SERVICE BULLETIN

Reference:	342-49-047 – SERVICE BULLETIN
Title:	Update of gas generator configuration
Issue number:	001
Issue Date:	27-apr-2023

Applicability: APU equipped with gas generator P/N 341-01-11

The purpose of this Service Bulletin is to describe the procedure to be performed by the end user or MRO center to retrofit gas generator P/N 341-01-11 into gas generator P/N 341-01-12.

Figure 3 : Update of Gas Generator Log Book to be implemented

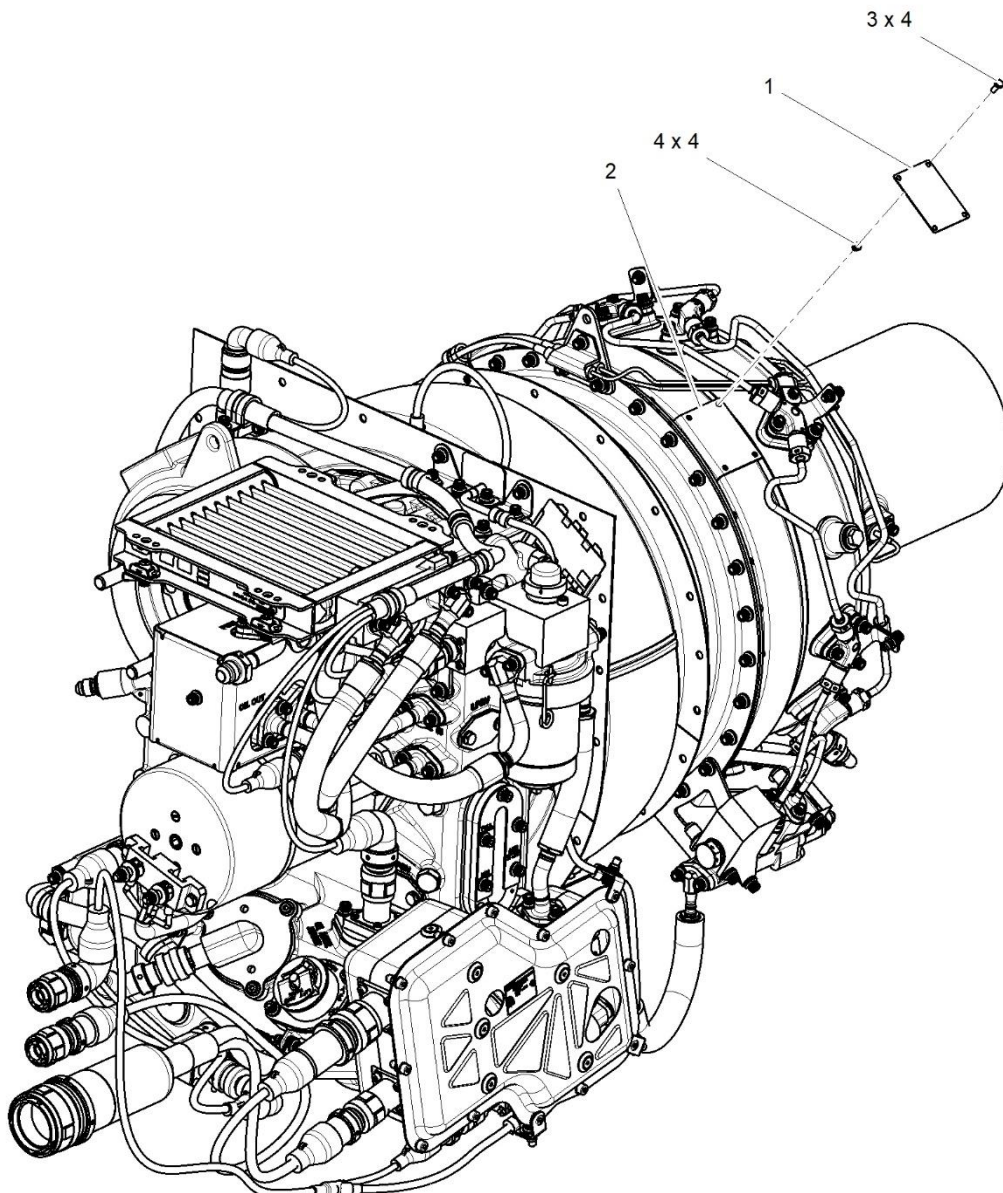
3.2. Remove and discard the four nuts (Figure 3, 4) and the four screws (3) that attach the identification plate (1) to the identification plate holder (2).

3.3. Discard the identification plate (1).
